On March 31, 2016 the City of Tualatin approved with conditions AR 15-0029 for Lam Research Building D Expansion located at 11155-11361 SW Leveton Dr (Tax Lot: 2S123AA01000).

## ARCHITECTURAL REVIEW AND PUBLIC FACILITIES DECISION

AR-15-0029

Case #:	AR-15-0029
Project:	Lam Research Building D Expansion
Location:	11155-11361 SW Leveton Drive ( <a href="#">Tax Lot 2S1 23AA 01000</a> )
Tax Map/Lots:	2S1 22AA 500, 2S1 22AB 100 & 200
Applicant/Owner:	Lam Research, Inc.
Applicant's Rep:	Lee Leighton, Mackenzie, Portland, OR (503) 224-9560

**C2.1 SITE PLAN**

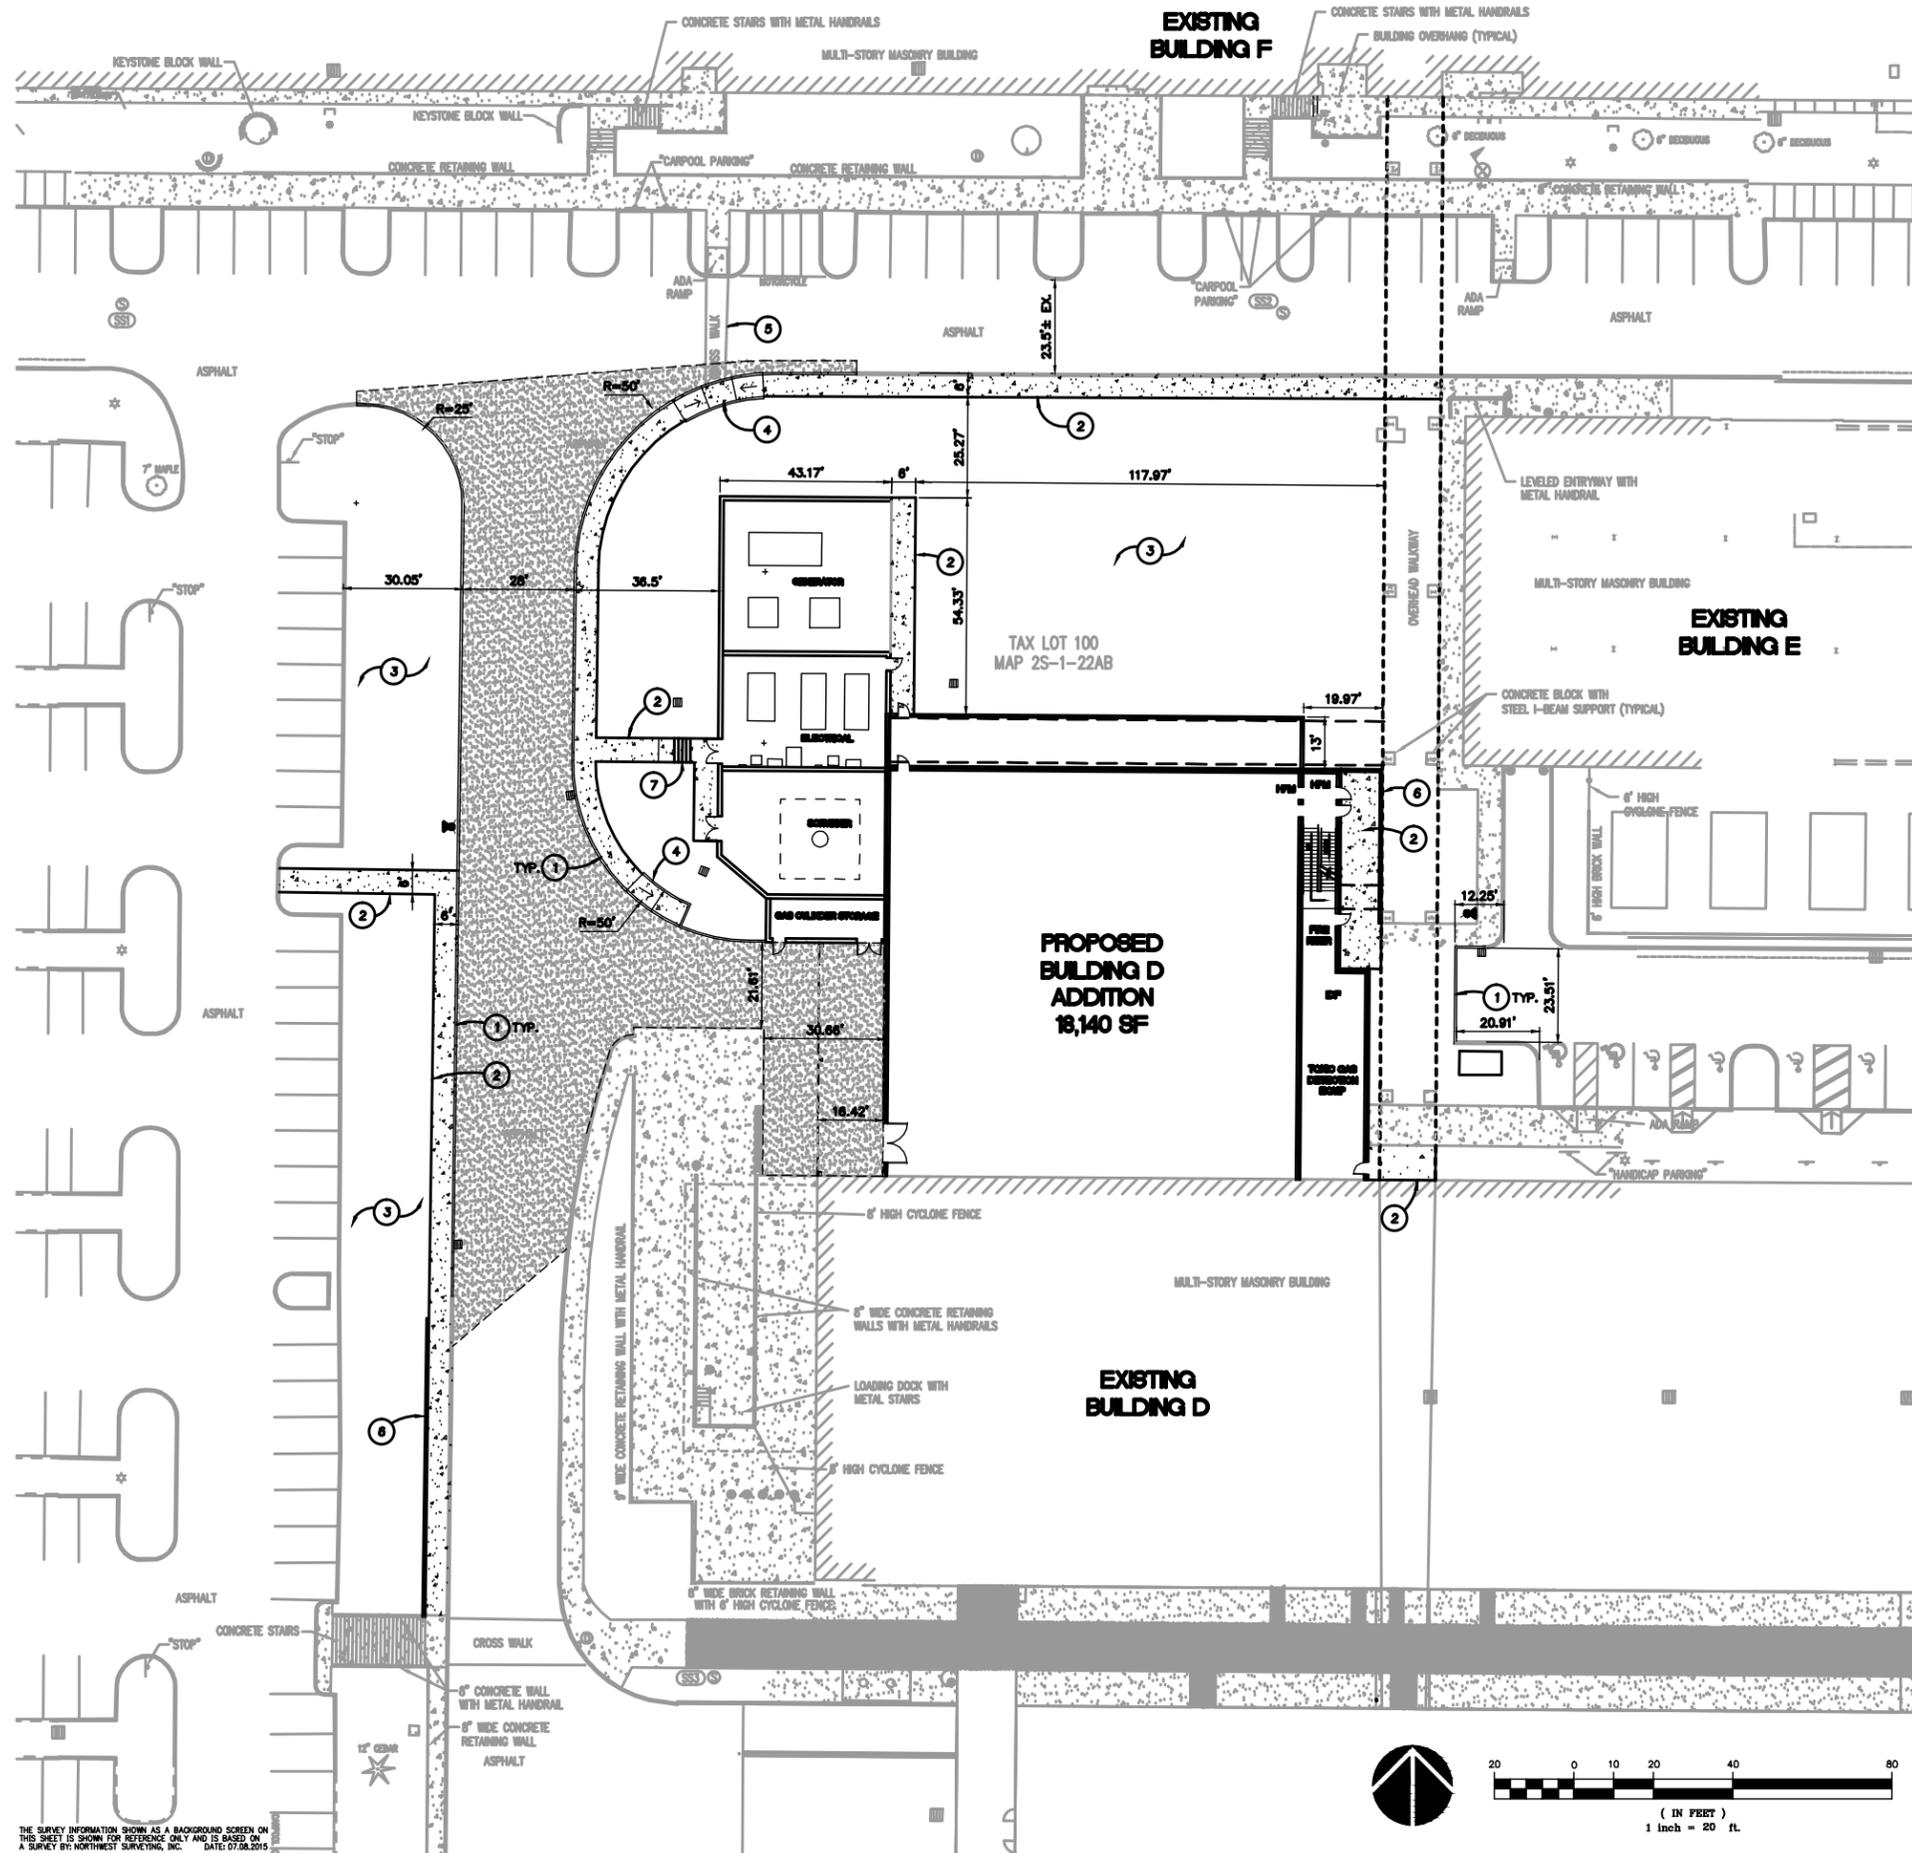
*The site plan, Sheet C2.1, shows the eastern side of the generator enclosure open. Staff finds that a generator is in a general category of equipment requiring security precautions described in Section 73.160(3)(f). A security fence or wall at least 6' tall is required.*

*The site plan, Sheet C2.1, shows the eastern side of the generator enclosure open. Staff finds that a generator is in a general category of equipment requiring screening described in Section 73.160(4)(a). A sight obscuring fence or wall or landscaping is required.*

- AR 2. Revise plans to provide a security fence or wall at least 6' tall completing the enclosure of the generator on the northwest corner of the proposed addition. TDC Section 73.160(3)(f)
- AR 3. Revise plans to provide a sight obscuring fence, wall or landscaping screening the generator on the northwest corner of the proposed addition. TDC Section 73.160(4)(c)
- AR 4. Revise plans to provide at least 119 square feet of additional trash enclosure area or revise the applicant's narrative to support the use of an alternative method described in TDC Section 73.227. TDC Section 73.227

**C2.3 UTILITY PLAN**

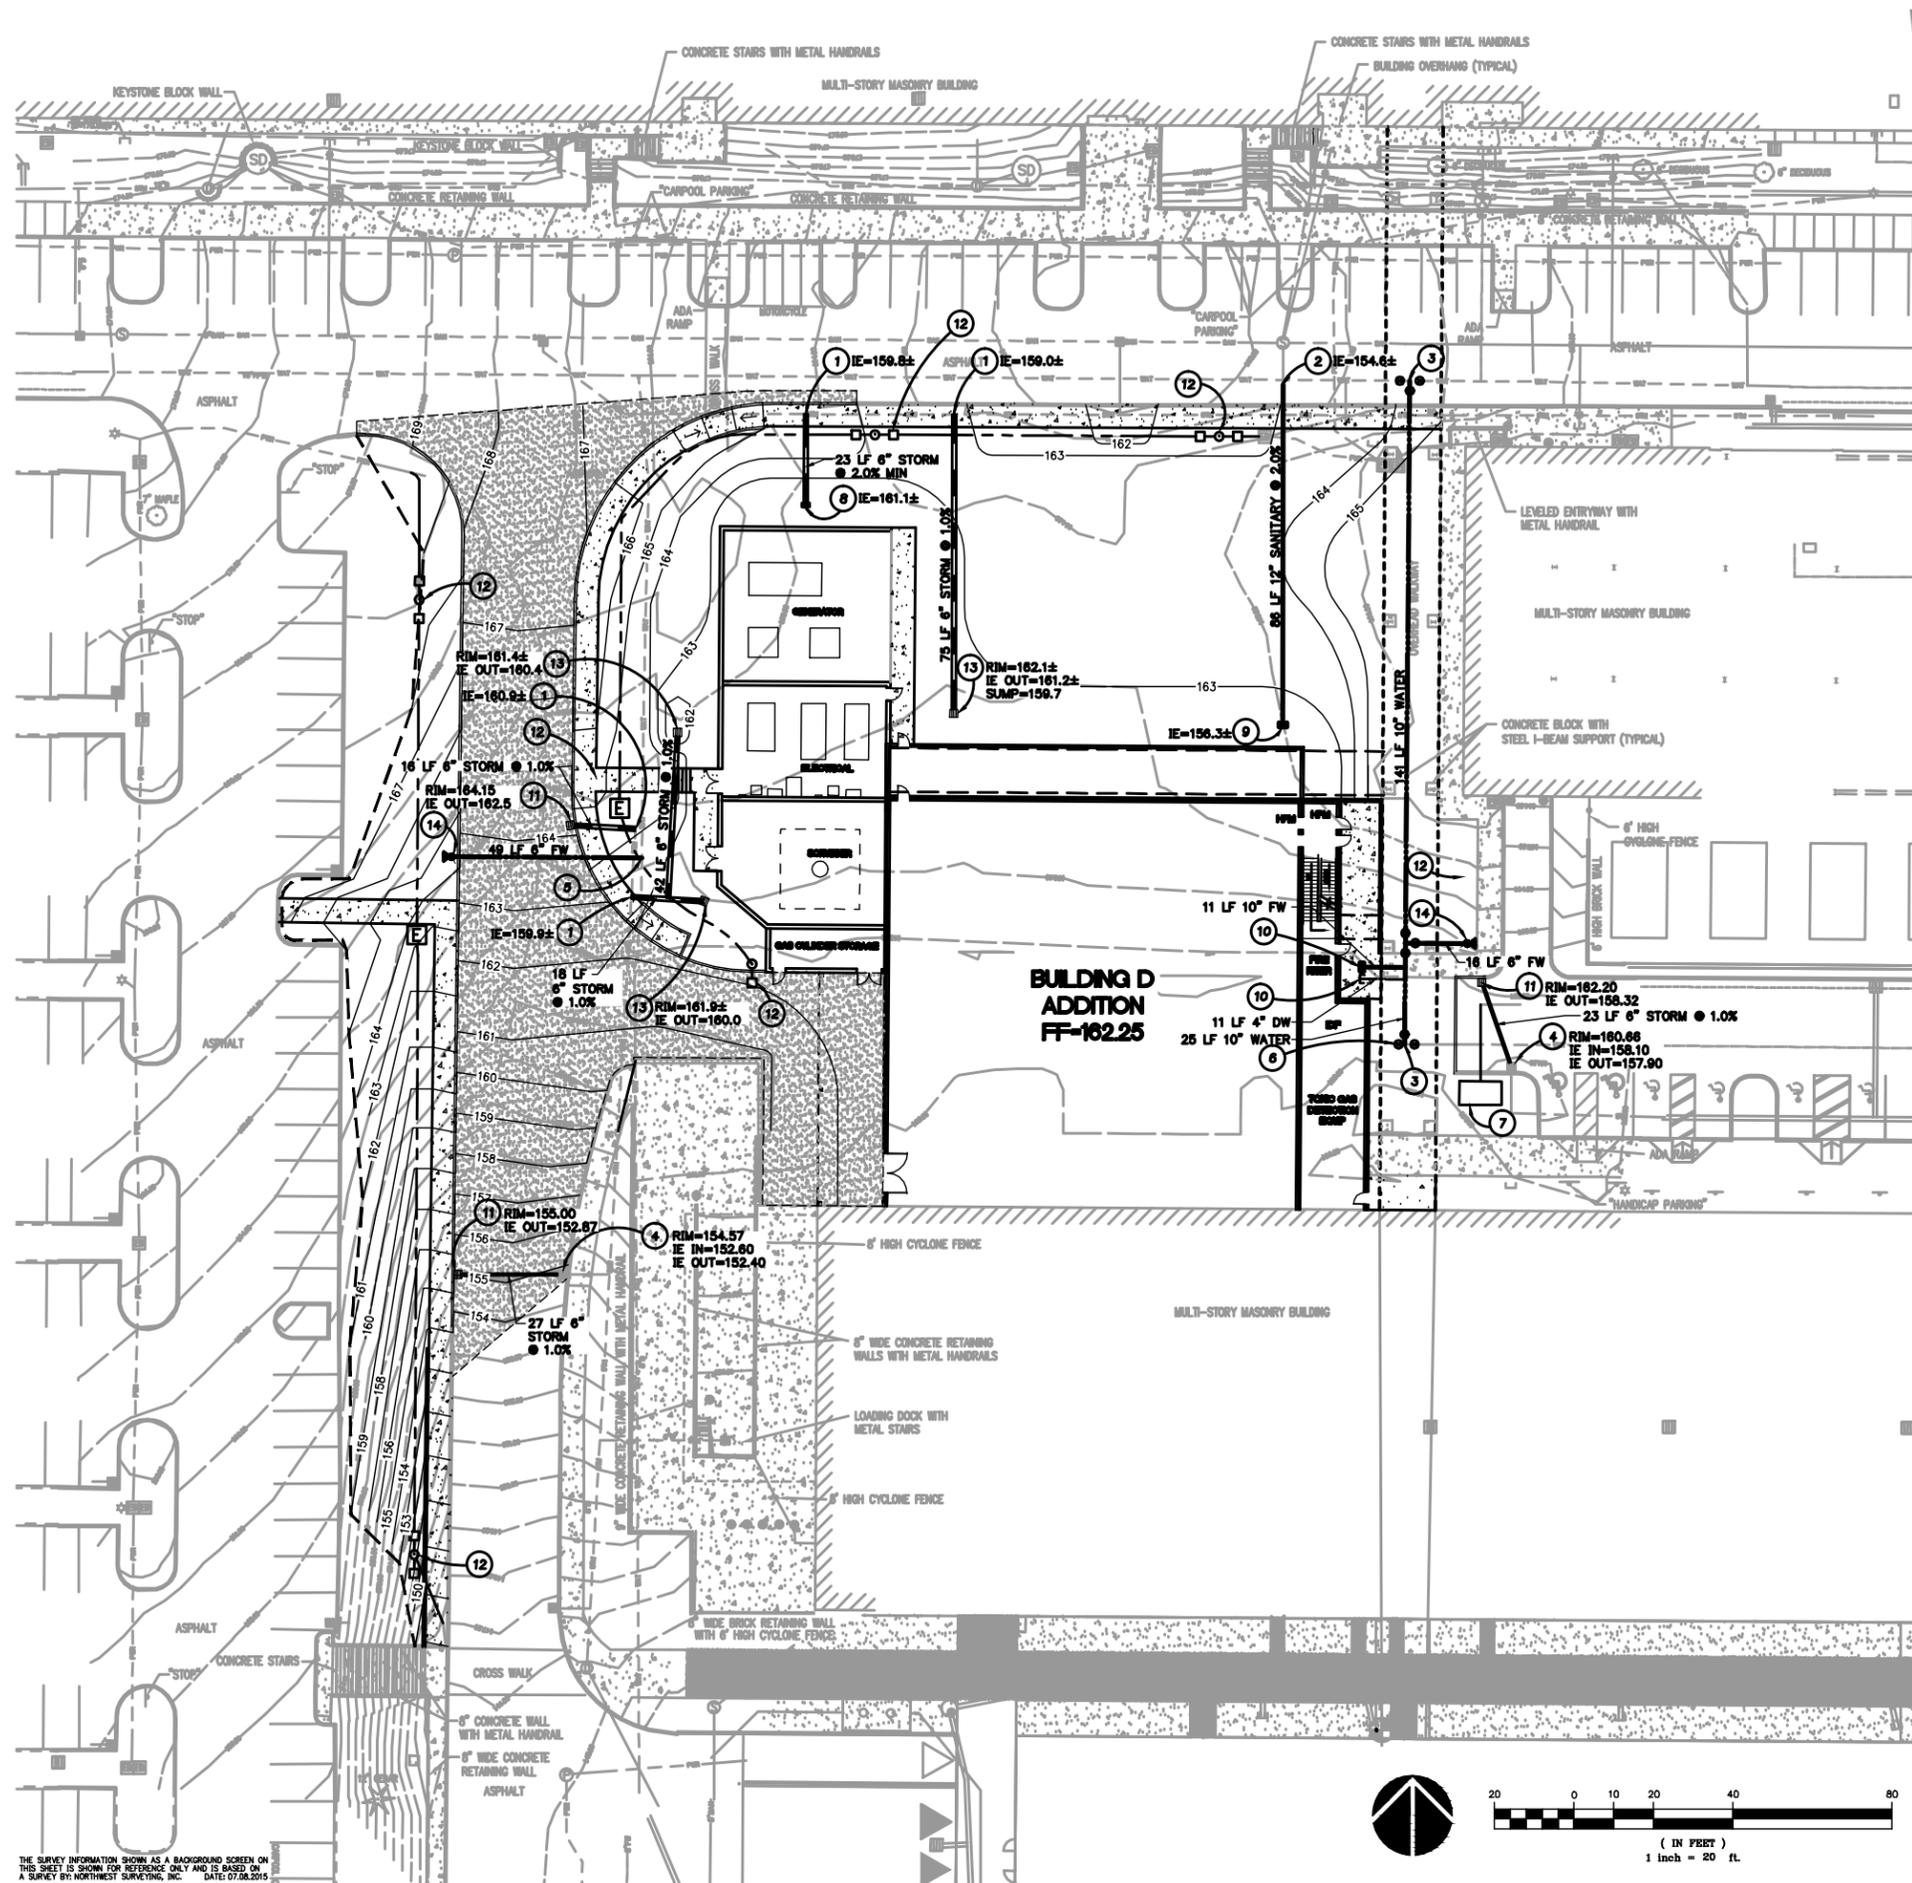
An additional gravity 12" private sewer lateral to serve the proposed Building D expansion is shown on Sheet C2.3, but it connects to an existing private sewer line within the property. No change is proposed in the property's connections to the public sanitary sewer system. Compliance with applicable standards will be achieved through City permitting procedures for on-site sewer construction.

An additional 10" private water lateral to serve the proposed Building D expansion, including installation of a new fire hydrant east of the building addition, is shown on Sheet C2.3, but it connects to an existing private water line within the property. No change is proposed in the property's connections to the public water system. Compliance with applicable standards will be achieved through City permitting procedures for on-site water line construction, including appropriate controls and other devices required by applicable codes.
